PRODUCT / PROCESS CHANGE NOTIFICATION

1.1 Company		STMicroelectronics International N.V
1.2 PCN No.		ADG/22/13788
1.3 Title of PCN		IPAK AI wire line relocation from Shenzhen to Tongfu Microelectronics (China)
1.4 Product Category		Power MOSFET HV, IGBT
1.5 Issue date		2022-11-22

IPAK Al wire line relocation from Shenzhen to Tongfu Microelectronics (China) INDUSTRIAL

Comparison IPAK Shenzhen vs TFME

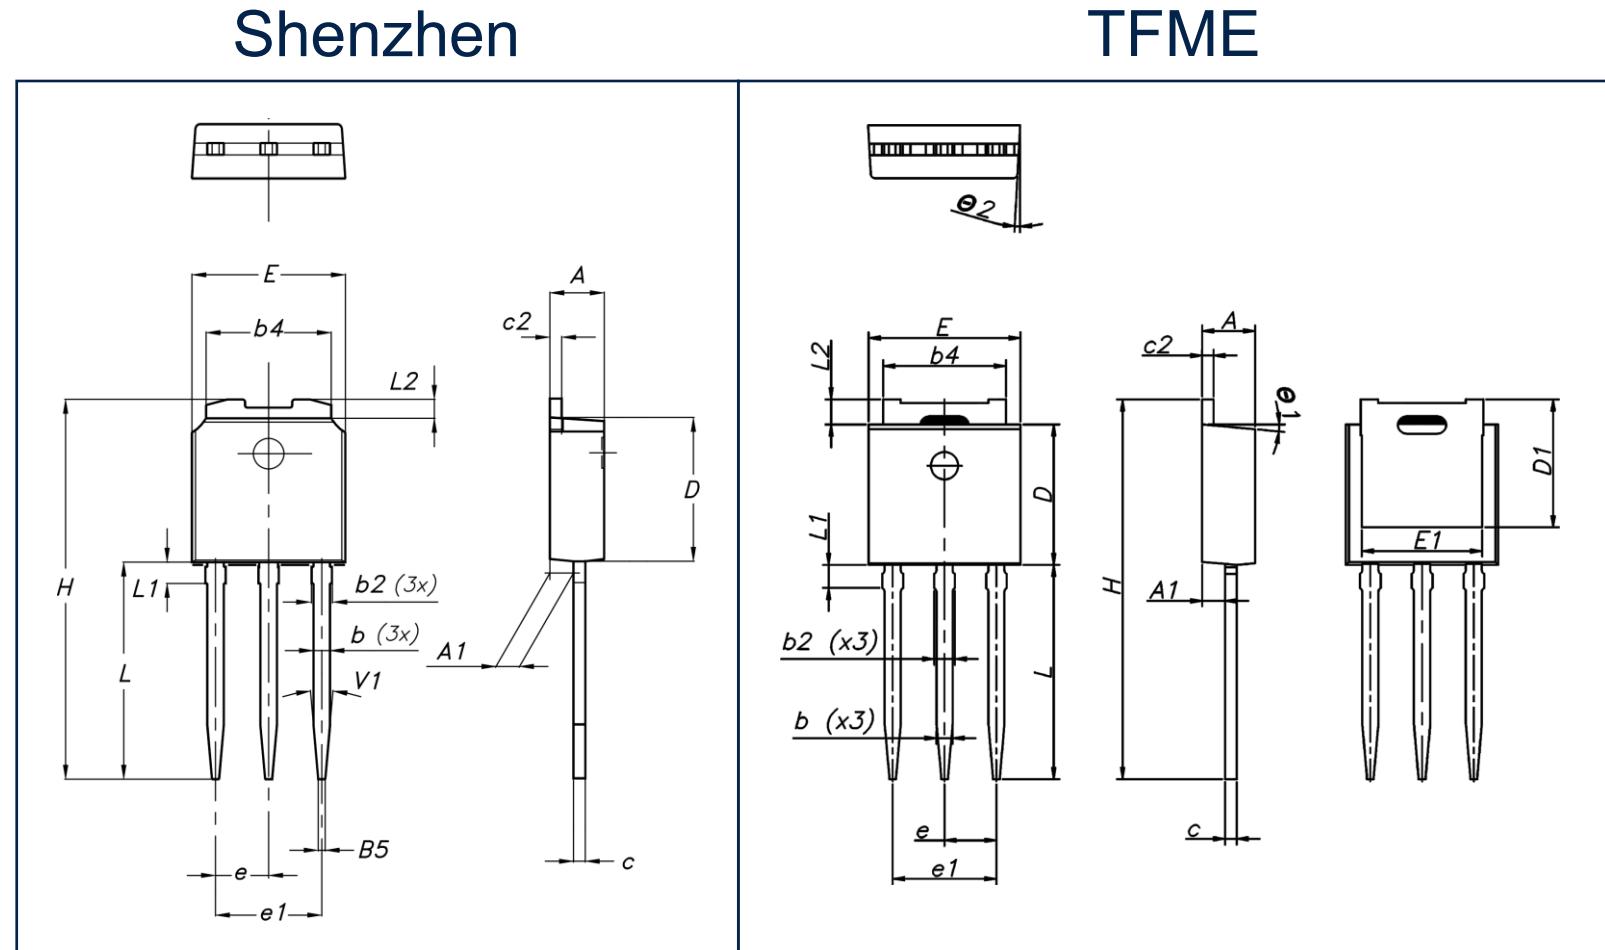
Shenzhen (type A)			TFME (type E)				
Dim.	mm		Dim.	mm			
	Min.	Typ.		Min.	Typ.	Max.	
A	2.2		2.4	A	2.2	2.3	2.35
A1	0.9		1.1	A1	0.9	1	1.1
b	0.64		0.9	b	0.66		0.79
b2			0.95	b2			0.9
b4	5.2		5.4	b4	5.23	5.33	5.43
B5		0.3					
c	0.45		0.6	c	0.46		0.59
c2	0.48		0.6	c2	0.46		0.59
D	6		6.2	D	6	6.1	6.2
				D1	5.3	5.53	5.75
E	6.4		6.6	E	6.5	6.6	6.7
				E1	5.05	5.23	5.4
e		2.28		e	2.2	2.25	2.3
e1	4.4		4.6	e1	4.4	4.5	4.6
H		16.1		H	16.18	16.48	16.78
L	9		9.4	L	9	9.3	9.6
L1	0.8		1.2	L1	0.8	1	1.2
L2		0.8	1	L2	0.9	1.08	1.25
V1		10°					
				θ1	3°	5°	7°
				θ2	1°	3°	5°
